Our ref: DOC22/34911

Your ref: MP10_0118 MOD 12

Subject: EES comments on Environmental Assessment for the Major Project Modification for Edmondson Park South Concept Plan – MP10_0118 MOD 12– Ed Square, North-West Quadrant, Edmondson Park

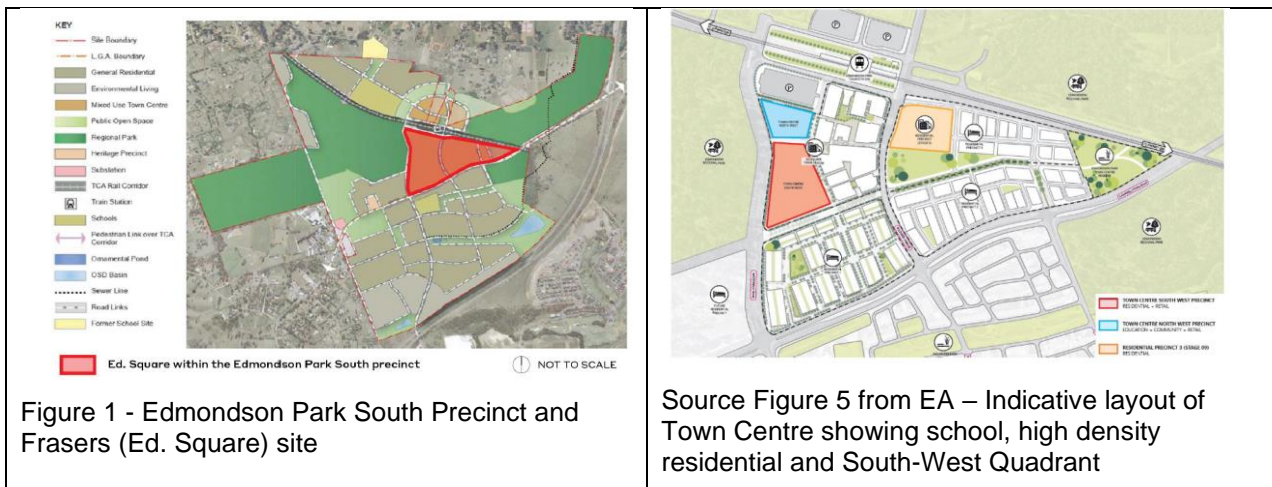
It is important the MOD 12 proposal provides an adequate APZ (and any other bushfire protection measures) within the boundary of the SFPP land and /or Macdonald Road which is located between the school site and the Regional Park. Any APZ measures must be located entirely outside the Regional Park within the development area. This is consistent with Condition 1.10 of the Edmondson Park Concept Plan Instrument of Approval (MP10-0118) dated 18 August 2011 which states:

- 1.10 Future subdivision applications are to demonstrate that the APZs are located outside any area of public open space, unless agreed to by the relevant council, and outside the regional park, unless agreed to by Office of Environment and Heritage.

Under no circumstances should the proposed MOD 12 development require any clearing of vegetation in the Regional Park for bushfire protection or for any other reasons.

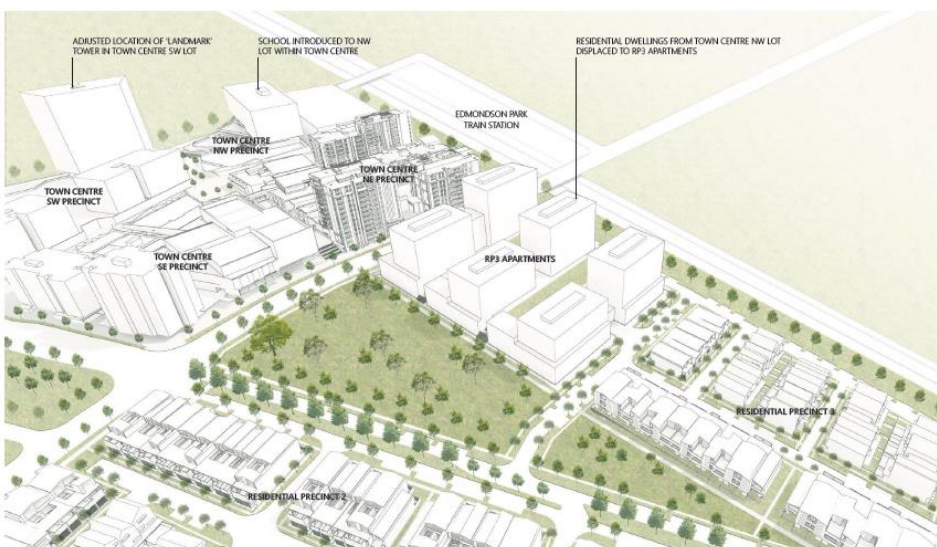
As the WQ14 link has the potential to impact CPW within the Regional Park, EES previously recommended the MOD 11 proposal undertakes an assessment and the WQ14 link be amended to avoid and/or minimise impacts on biodiversity values. EES noted important details are lacking about the scale, area, intensity, method and duration of works associated with the WQ14 link, and this may have a bearing on the level of direct and indirect impacts on biodiversity values

The RtS for MOD 12 needs to clarify if it is proposed to locate the drainage solution within the Regional Park. EES does not support the locating WQ14 link in the Regional Park, As noted above, the proposed modification should not give rise to any environmental impacts on the Regional Park.
